1-3 Orange St.

Condos

Condominiums
 Project Name/Description

TO: Ethan Boxer-Macomber – Planner
FROM: Jim Seymour – Development Review Coordinator, Sebago Technics, Inc.
RE: Proposed Residential Duplex/Condo Building: 1 Orange St/Salem St.
DATE: January 31, 2005

Front Elevation **ORANGE**

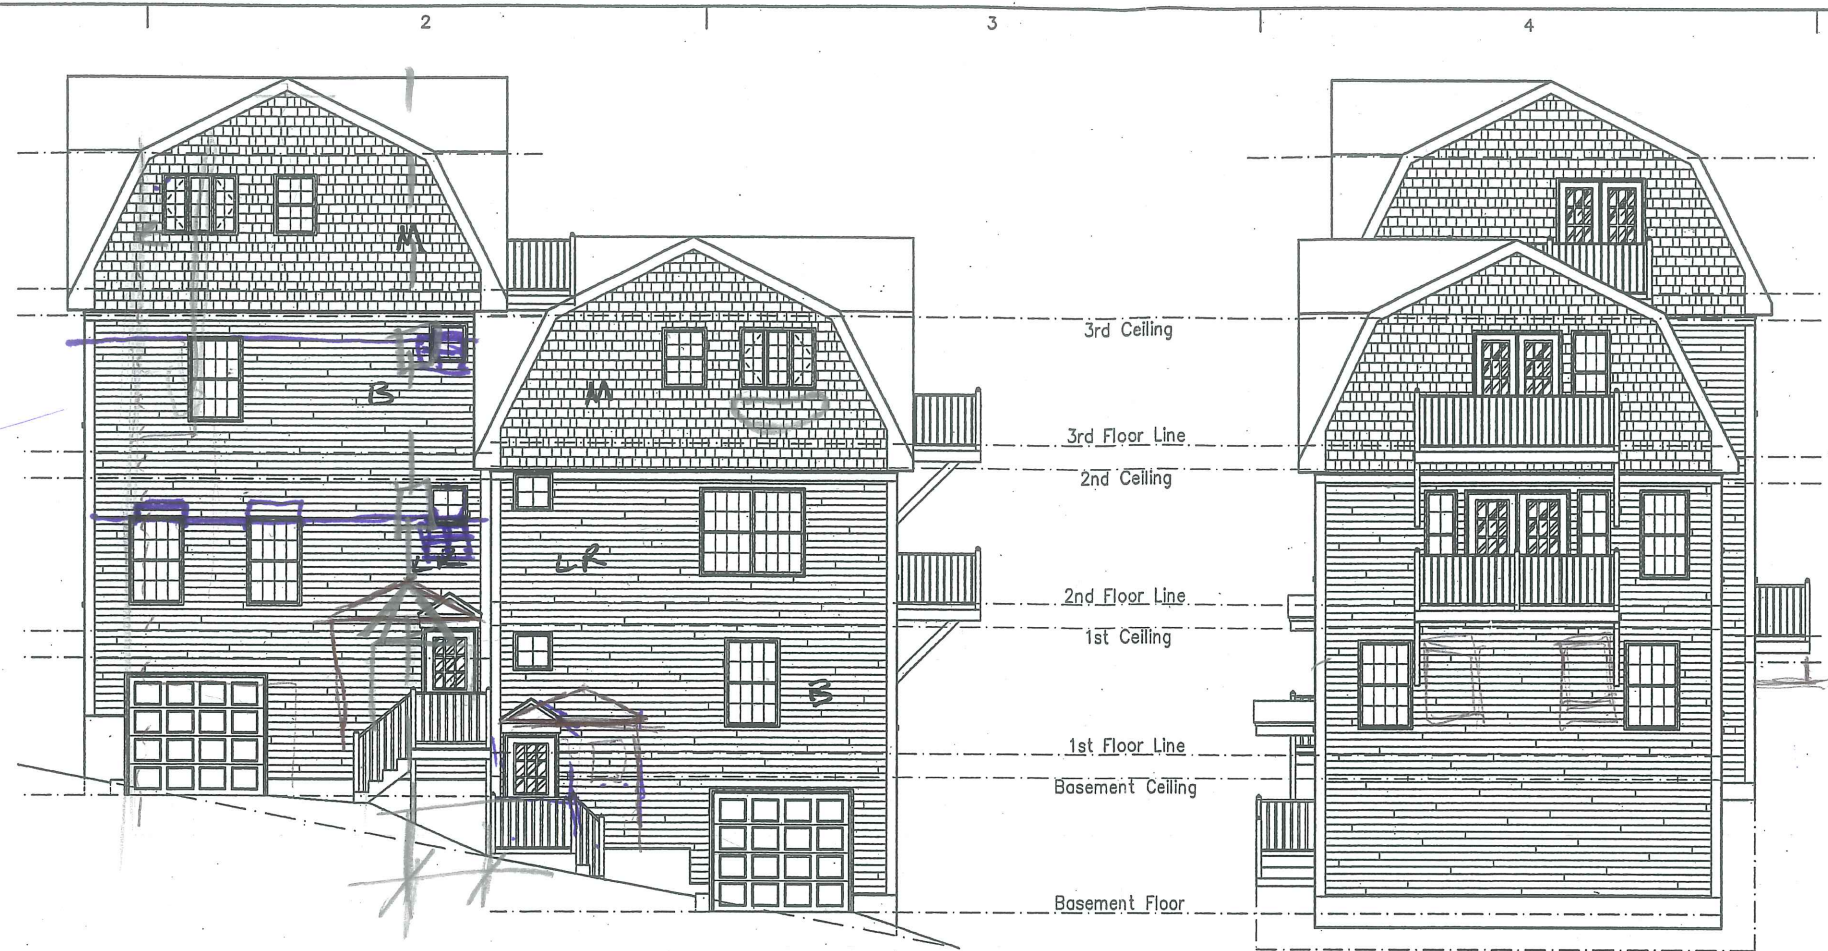
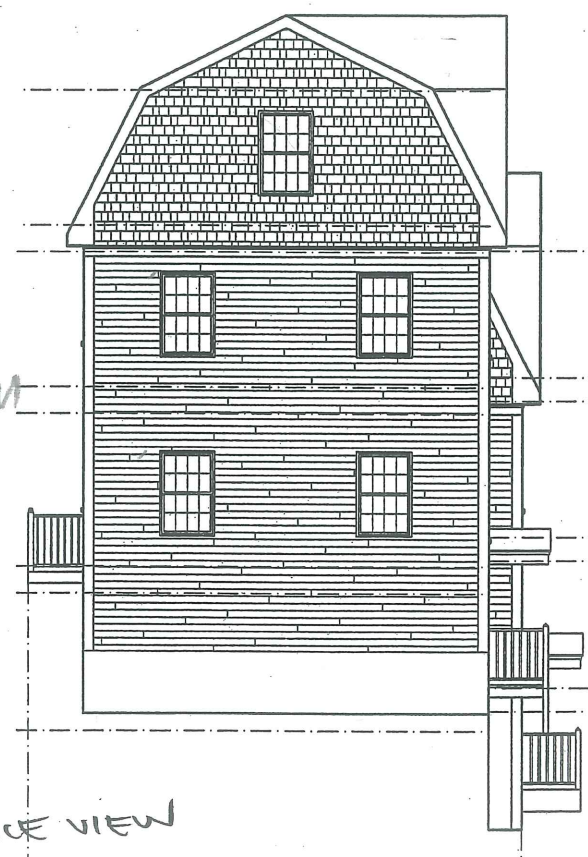
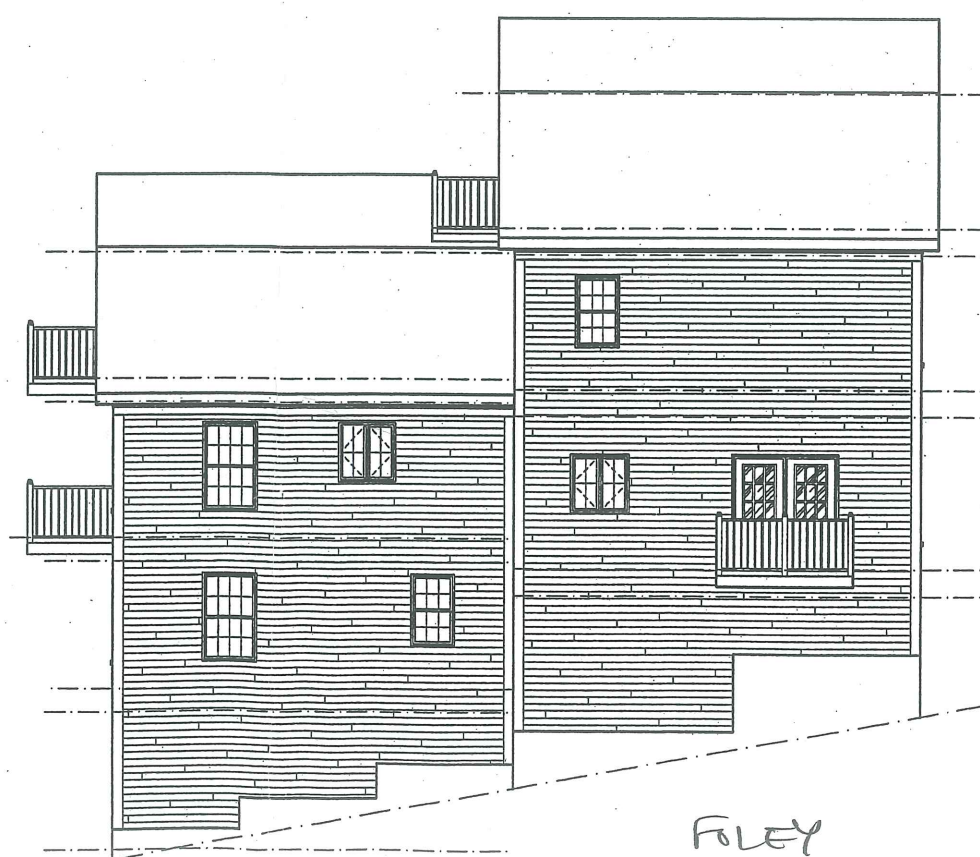
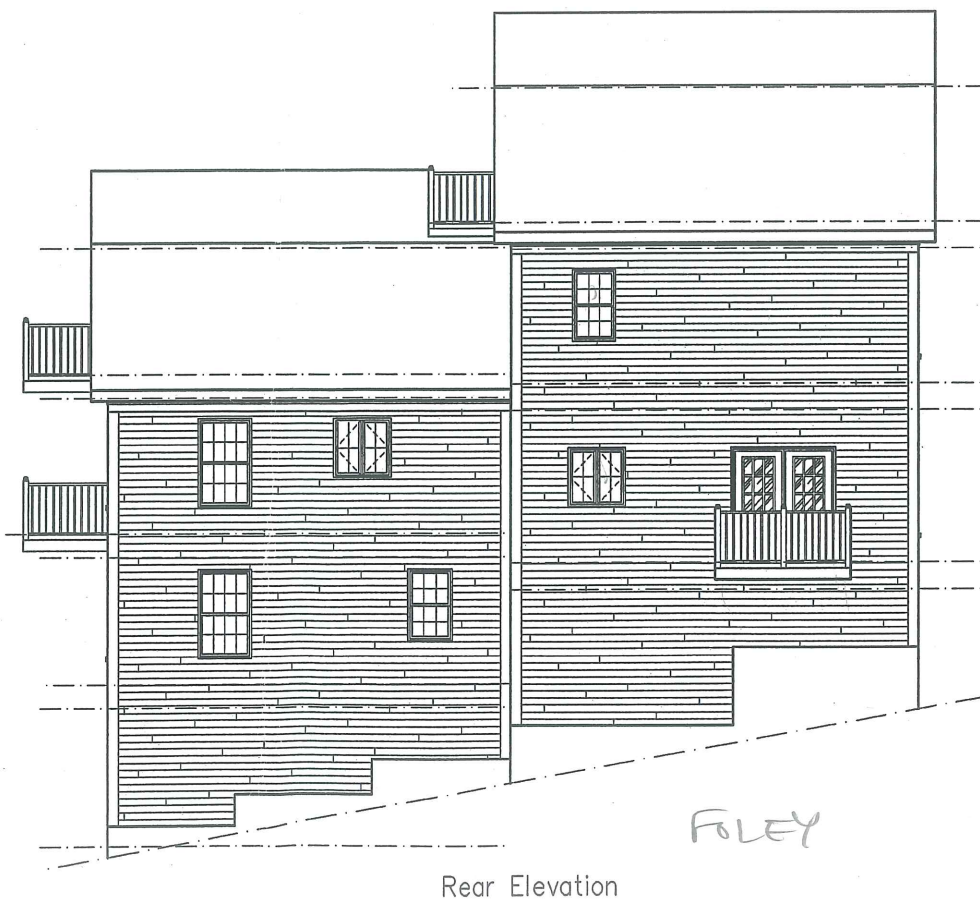
Front porches on Orange Street must be widened slightly in order to be 20% of the overall width of the front façade. Please show dimensions of both porch and overall building widths.

The projects north façade is in full compliance with these standards. The remaining three facades, all of which are readily visible from the public right of way, are not. These facades must be revised so as to achieve the orderly vertical alignment and discernable vertical axis lines of the north façade.

Multiple window types employed throughout the buildings. You may either (1) revise or (2) present a justification narrative.

Siding materials not indicated. You have stated that these will be Hardy-Plank (primary walls) and interlocking vinyl panels, which replicate wood shakes (gambrel ends). Please indicate on plans.

The project, as proposed, features a blank wall at Salem Street, the façade with the greatest influence on the streetscape. In order to meet the spirit and intent of Principle F, please provide appropriate fenestration consistent with the design standards.
